MONTICELLO NUCLEAR GENERATING PLANT  
Docket No. 5C 263 License No. DPR-22

Supplemental Information on EOC Transient  
Analysis Requested in October 18, 1973 Letter

FIGURE I  
Simplified Arrangement of MSIV  
Position Switches in Reactor Protection System

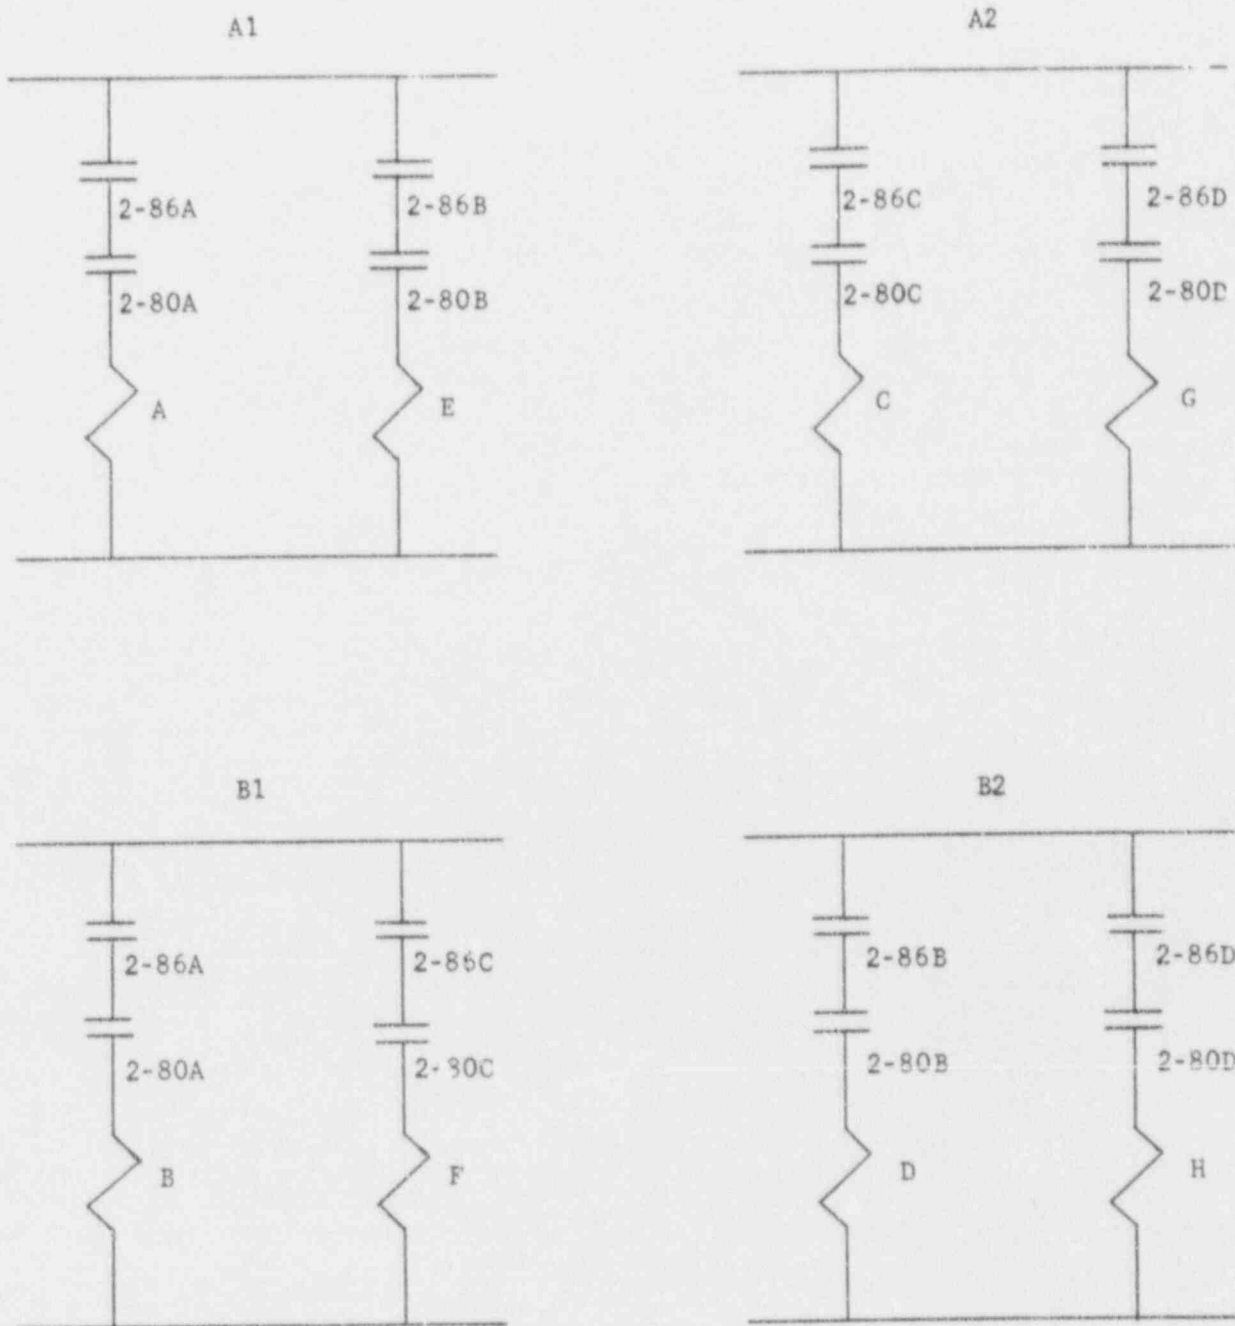
The reactor protection system is a one out of two taken twice logic. A scram occurs on de-energization of the (A1 or A2) and (B1 or B2) subchannels. Failure to scram therefore occurs when the (A1 and A2) or (B1 and B2) channels remain energized. The attached Figure 1 shows in simplified form, the arrangement of MSIV position switches in the scram logic. The 2-80 A through D and 2-86 A through D switches are the inboard and outboard MSIV position switches, respectively, for the four main steam lines. Through additional curcuitry, the A1 subchannel is said to be energized when either the A or E relay is energized and so forth.

Suppose the failure to scram involves failures causing the A1 and A2 subchannels to remain energized during an MSIV closure. This would require the (A or E) and (C or G) relays to remain energized. For the A relay to remain energized, both position switches 2-86A and 2-80A must fail to open as designed. Likewise, for the C relay to remain energized, switches 2-86C and 2-80C must fail to open. Failure of the direct scram in the MSIV closure event can therefore occur only when specific combinations of four or more of the eight valve position switches fail in either the A or B channel; a very unlikely situation.
